SEWAGE DISPOSAL SYSTEM

HOWARD COUNTY HEALTH DEPARTMENT

ADDRESS 14079 Brighton Dam Road, Clarksville, Maryland 21029 PHONE 854-2006

SUBDIVISION _____ LOT _____ ROAD 5790 Ten Oaks Road

57364A

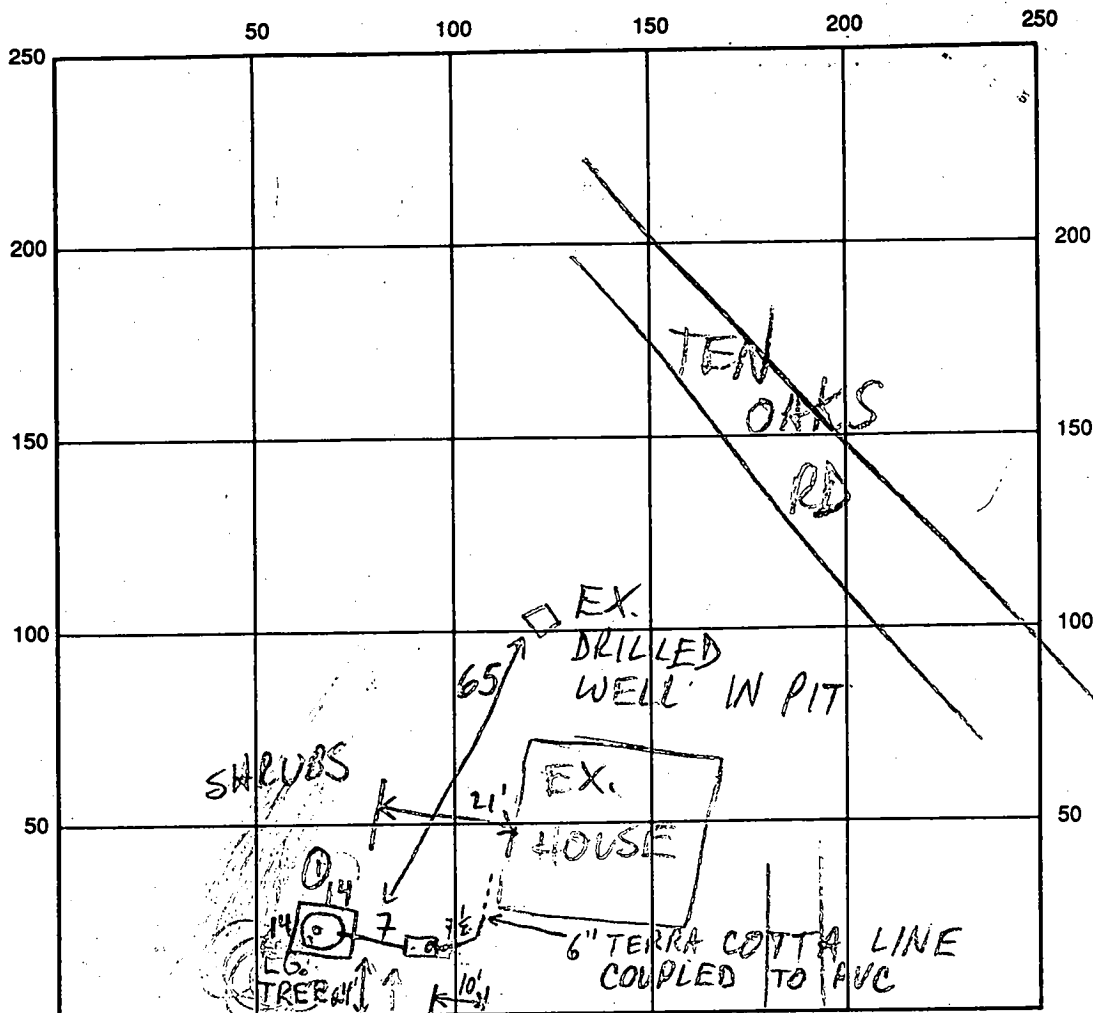
DRYWELL 14' SQUARE, 9' STONE MR 10/28/96

TRIA MILL RD 200'± TO WELL ACROSS RD

REMARKS: 10/28/96 OK TO START; EX SYSTEM REPORTEDLY ACROSS

TRIA MILL RD (CESSPOOL) MR

10/30/96 OK TO FINISH & COVER MR

SITE INSPECTION SHEET

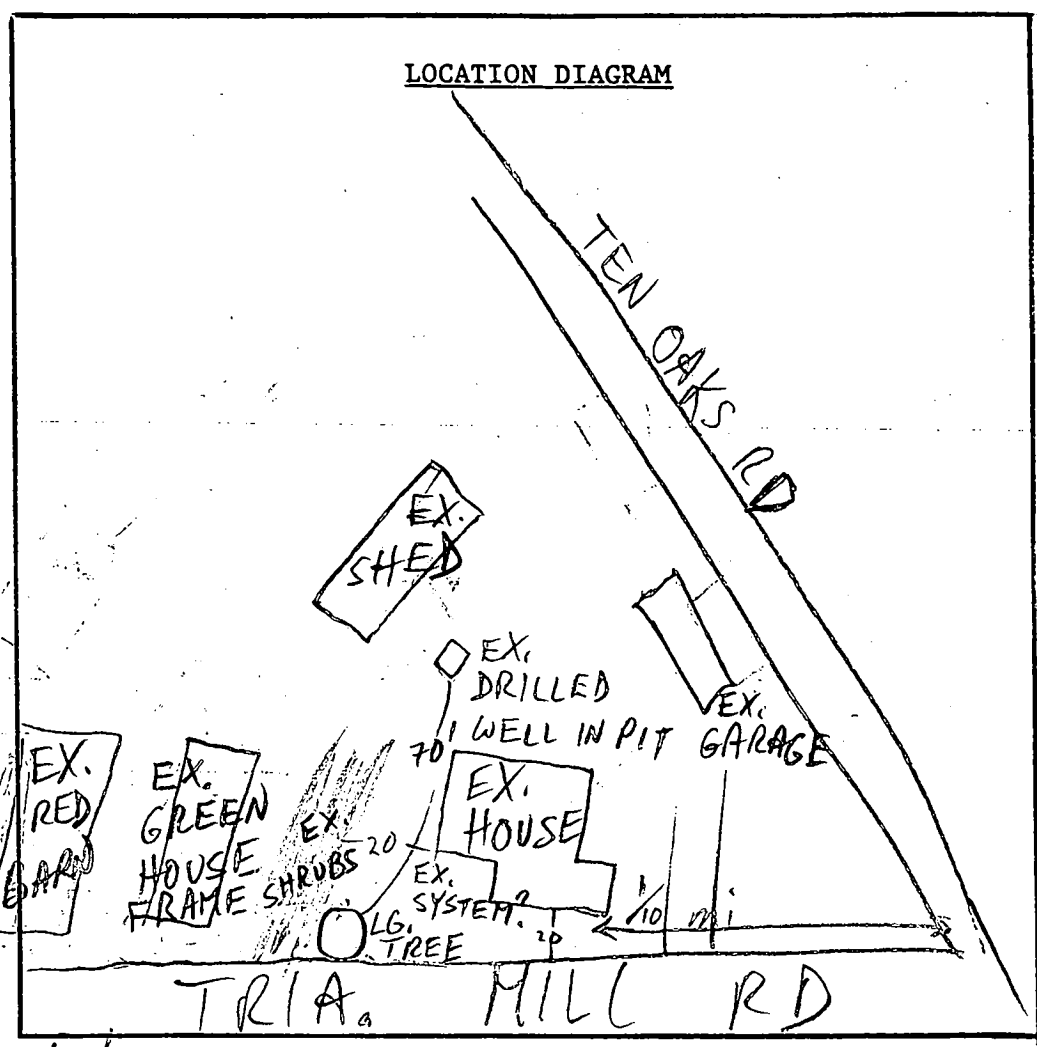
PROPOSAL: Site insp requested before septic system repair (for real estate transaction)

COMMENTS: 10/16/96 MET C. CISSEL: BEST OPTION IS D/W IN FRONT LEFT PORTION OF PROPERTY (NEAR TREE/SHRUBS), BUT NEED PROP. BOUNDARIES & INFO RE: ADJ. WELLS BEFORE INSTALLATION, OK TO PREPARE PERMIT MR
